Subject: Issuance of Amendment No. 1 to Facility Operating
License No. NPF-57 - Hope Creek Generating Station

HOPE CREEK GENERATING STATION

Amendment No. 1
License No. NPF-57

SAFETY EVALUATION BY THE OFFICE OF NUCLEAR REACTOR REGULATION

Figure 3.2.3-1

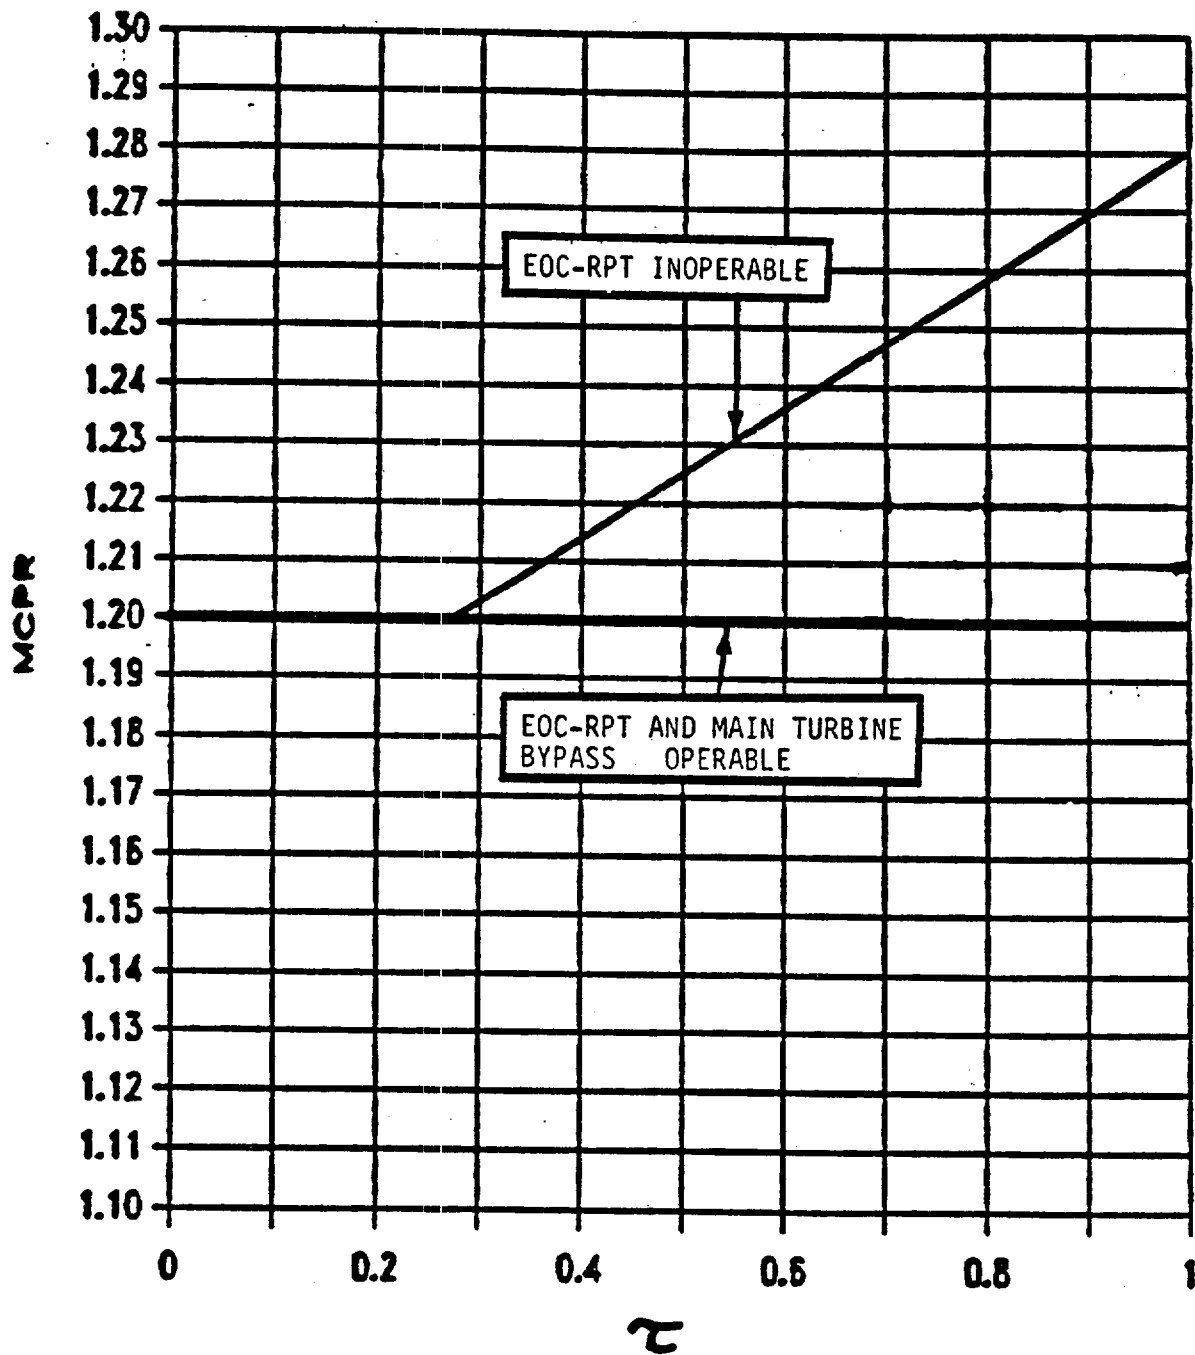
This amendment revises the Hope Creek Technical Specifications to include a Minimum Critical Power Ratio (MCPR) curve for instances when the End-of-Cycle Recirculation Pump Trip (EOC-RPT) is inoperable. The enclosed Technical Specification pages replace the corresponding pages currently in the Technical Specifications.

- a. With the end-of-cycle recirculation pump trip system inoperable per Specification 3.3.4.2, operation may continue and the provisions of Specification 3.0.4 are not applicable provided that, within 1 hour, MCPR is determined to be greater than or equal to the MCPR limit as a function of the average scram time shown in Figure 3.2.3-1, EOC-RPT inoperable curve, plus the feedwater heating capacity adjustment given in Table 3.2.3-1, times the K_f shown in Figure 3.2.3-2.
- b. With MCPR less than the applicable MCPR limit shown in Figures 3.2.3-1 and 3.2.3-2, plus the feedwater heating capacity adjustment given in Table 3.2.3-1, initiate corrective action within 15 minutes and restore MCPR to within the required limit within 2 hours or reduce THERMAL POWER to less than 25% of RATED THERMAL POWER within the next 4 hours.

shall be determined to be equal to or greater than the applicable MCPR limit determined from Figures 3.2.3-1 and 3.2.3-2:
